UNITED STATES PATENT AND TRADEMARK OFFICE

APPLICATION NO.	FILING DATE	FIRST NAMED INVENTOR	ATTORNEY DOCKET NO.	CONFIRMATION NO.
10/547,204	08/26/2005	Uwe Zoller	SMB-PT155 (PC 04 019 B US)	7991
3624	7590	09/28/2006	EXAMINER	
VOLPE AND KOENIG, P.C. UNITED PLAZA, SUITE 1600 30 SOUTH 17TH STREET PHILADELPHIA, PA 19103				BOECKMANN, JASON J
		ART UNIT		PAPER NUMBER
				3752

Office Action Summary	Application No.	Applicant(s)	
	10/547,204	ZOLLER, UWE	
	Examiner	Art Unit	
	Jason J. Boeckmann	3752

DETAILED ACTION

Examiners marked up figure 6

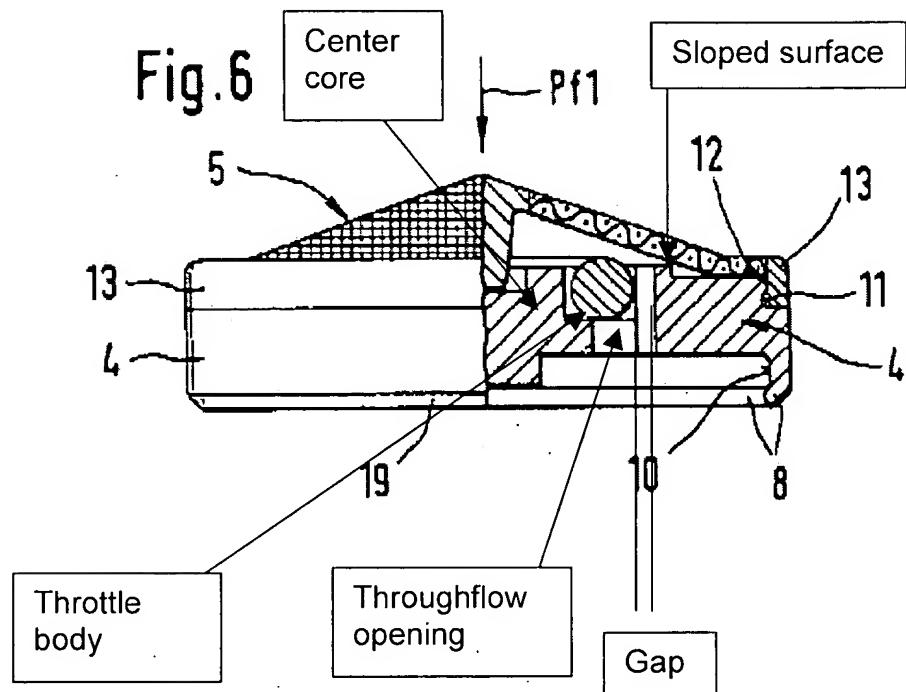
Regarding claims 3 and 7, the throughflow regulator has an exterior edge with a radially inward rising sloping surface (the top of the throughflow regulator where the surface steps up to substantially conform to the cross-section of the sieve (5) has a 90 degree inwardly rising sloped surface) which leads to a throughflow opening connected to a control gap (see examiners marked up figure 6 below). The control gap is also provided with a central core area which is surrounded by a throttle body and the rising sloped surface having a throughflow cross-section being adjustable by the throttle body.
